ATTACHMENT #3

Thank you for the opportunity to provide input on the FAA's recent proposal for a modified Runway Safety Area alternative at Juneau Airport.

We reviewed the information you provided in your 3/22/06 letter and attached RSA alternative sketch (JNU RSA Graphic.pdf) and analyzed the operational impacts of the proposal.

Landing Performance On Slippery Runways

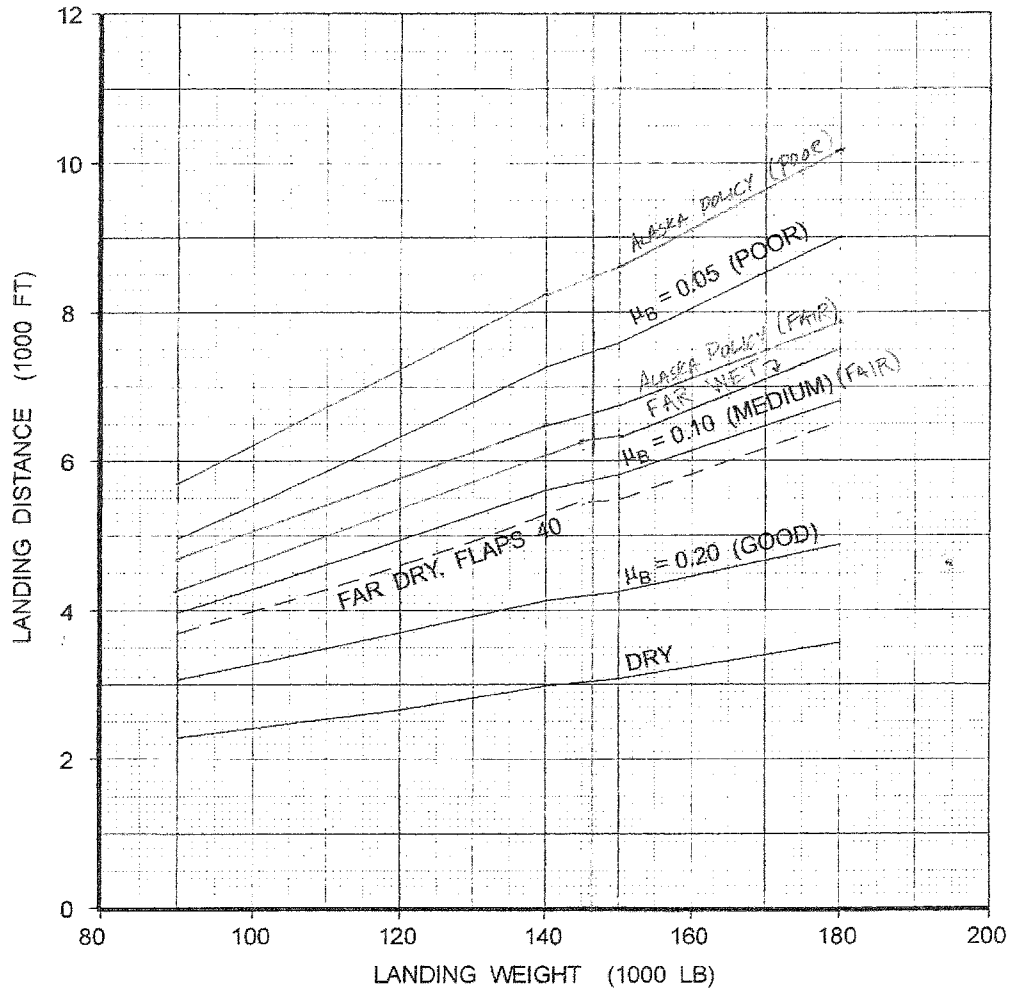
The attached file "900PEMLanding.pdf" shows the Advisory Landing Performance on Slippery Runways for the B737-900. As mentioned above, the FAR Dry and FAR Wet required landing distances are sufficiently within the proposed landing distance at JNU. Added to the PEM pages are lines depicting Alaska Airlines' policy regarding landing on runways with reduced braking action. Note that with Poor braking action, the airplane would not be able to achieve maximum landing weight of 146,300 lbs., which would cause a diversion to an alternate airport. If this became a probable scenario, i.e. the runway frequently had Poor braking action; the effect would be a reduction in the maximum weight capability we plan for when flying to JNU.

As can be seen in the attached PEM graph, the only time landing distance would be a concern to us is when the runway braking action degrades to poor. This can largely be avoided if the airport has an effective program to clear the runway of snow, slush and ice - something we emphasize at all our airports where this could be an issue.
